EDWIN I. HATCH NUCLEAR PLANT, UNIT NO. 2

AMENDMENT TO FACILITY OPERATING LICENSE

Amendment No. 42
License No. NPF-5

ATTACHMENT TO LICENSE AMENDMENT NO. 42

FIGURE 3.4.1.1-1
THERMAL POWER LIMITATIONS DURING OPERATION WITH LESS THAN
TWO REACTOR COOLANT SYSTEM RECIRCULATION LOOPS IN OPERATION

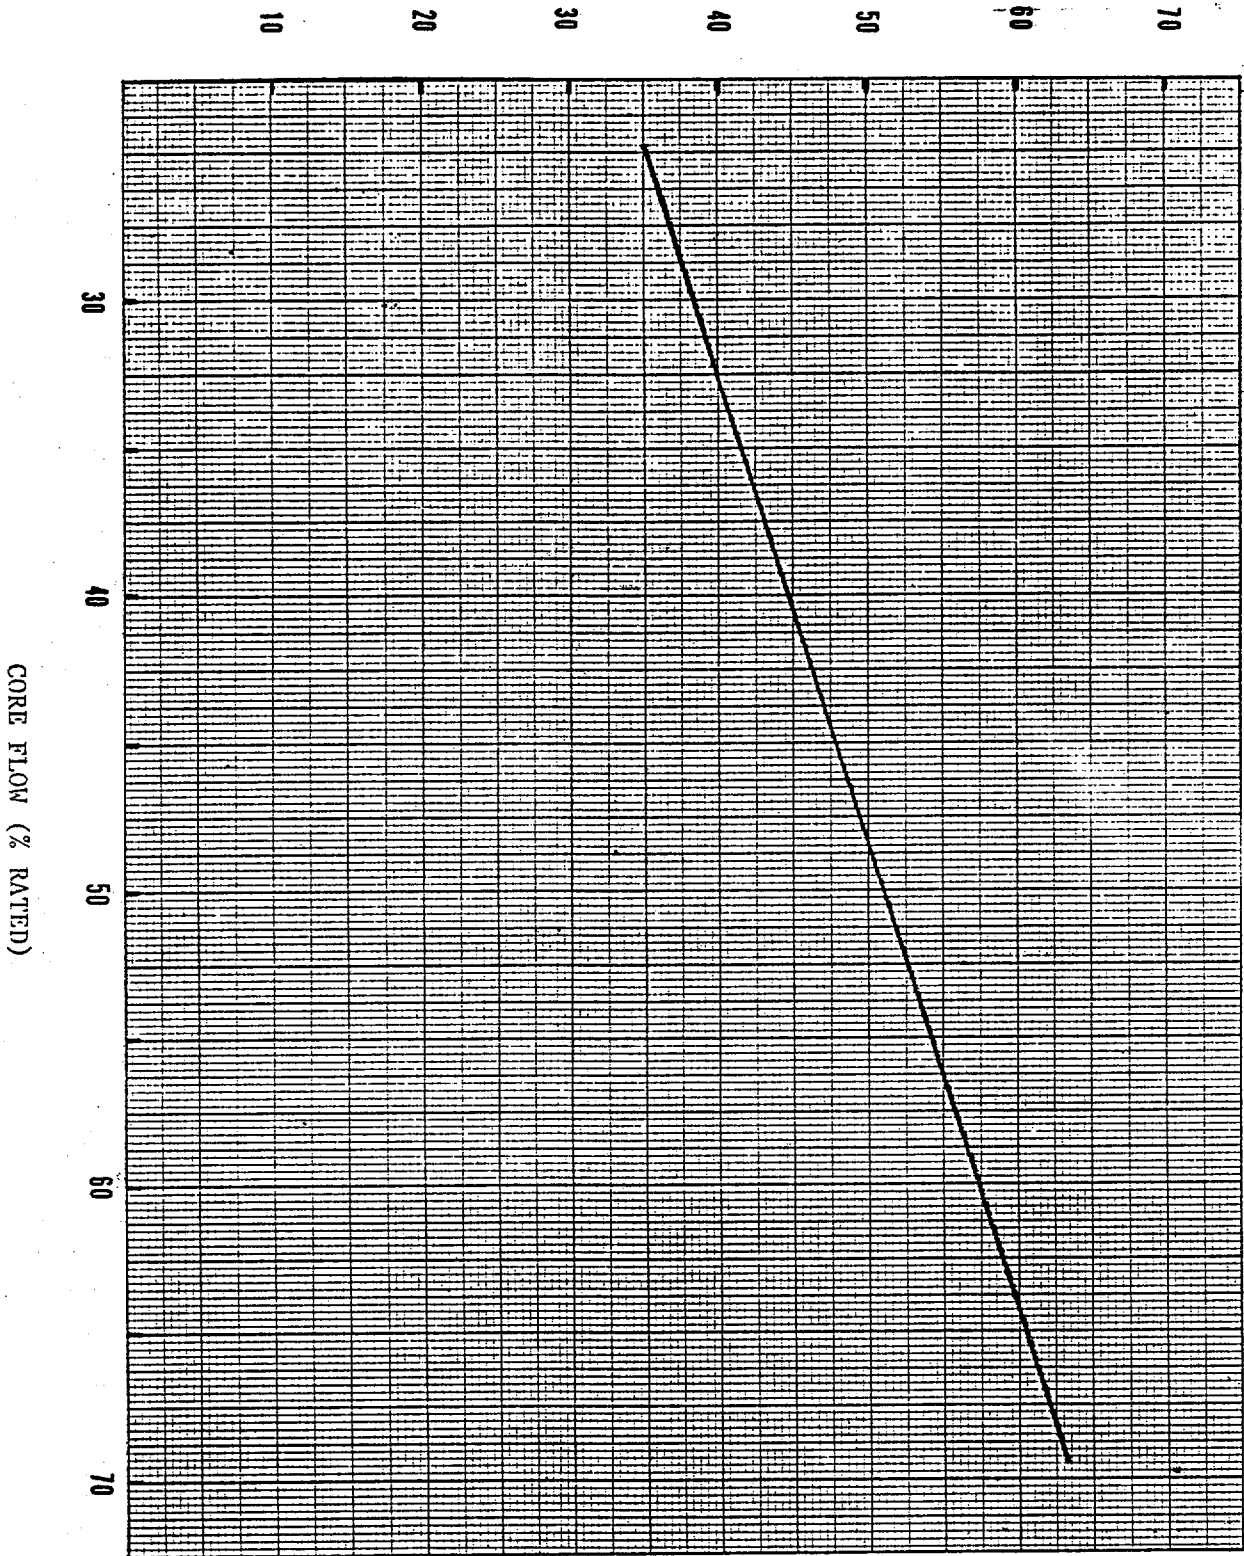
The amendment revises the TSs for Hatch Unit 2 to add a requirement to reduce the power below a specified limit whenever the plant is temporarily operating with only one recirculation loop.

- a. With one recirculation loop not in operation, initiate action within 15 minutes and continue action to reduce reactor power to or below the limit specified in Figure 3.4.1.1-1 within 2 hours and restore both loops to operation within 12 hours or be in at least HOT SHUTDOWN within the next 12 hours.
- b. With no recirculation loops in operation, place the reactor mode switch in the Shutdown position.

When operating with one recirculation loop, the plant will initiate within 15 minutes an orderly reduction in thermal power to less than a specified limit within 2 hours. This limit corresponds to a load line leading to 80% reactor power at rated core flow.
